Product Change Notification / ASER-14IXRW319

CCB 3430.007 Final Notice: Qualification of MTAI as an additional assembly site for selected PIC16xxx and PIC18xxx device families available in 28L QFN (6x6x0.9mm) package.

CCB 3430.007
Pre and Post Change Summary
PCN #: ASER-14IXRW319

Lead Frame Comparison

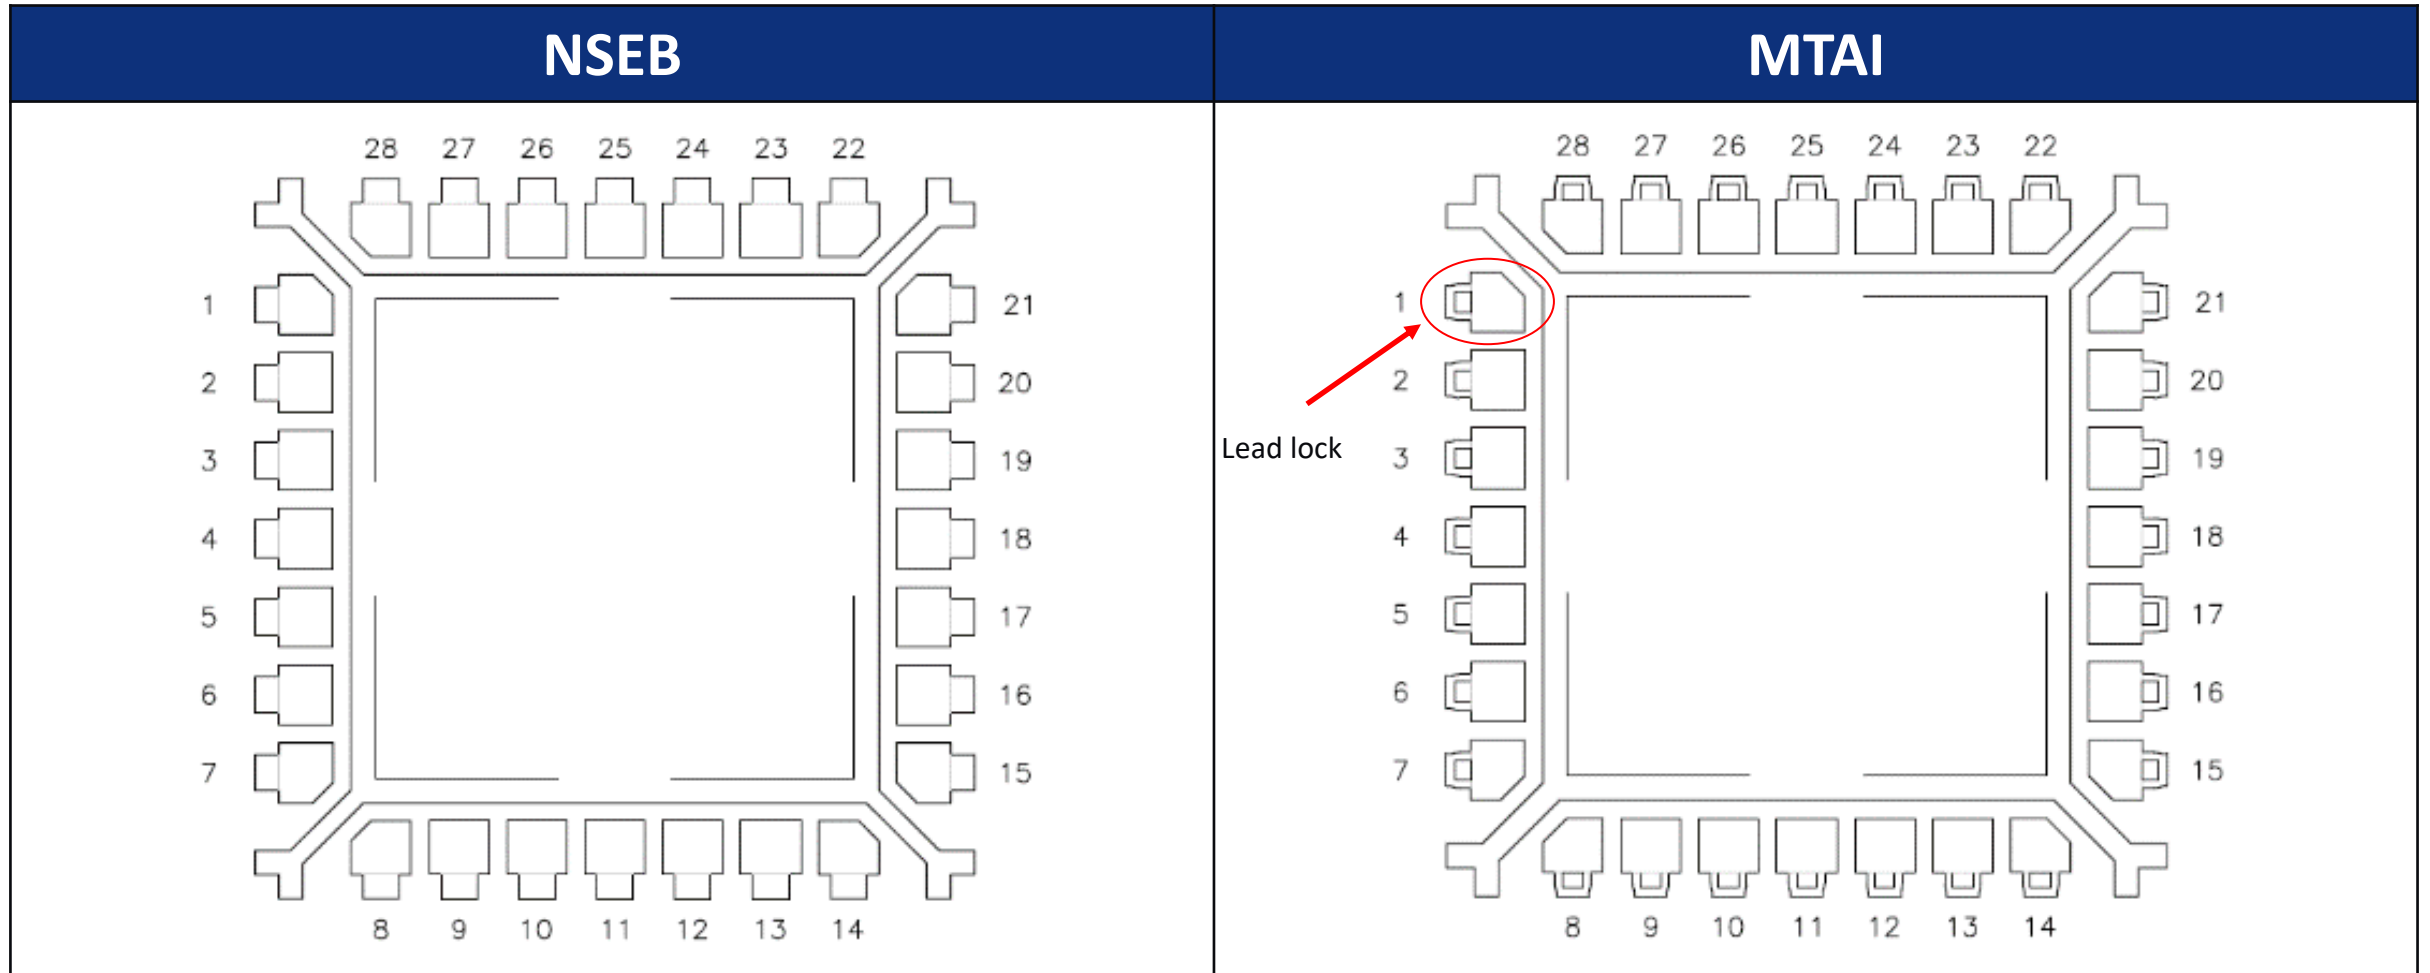
Note: Mold compound material fills the lead lock hole, which provides improved protection against moisture penetration along the edge of the leads (pins) of the package.
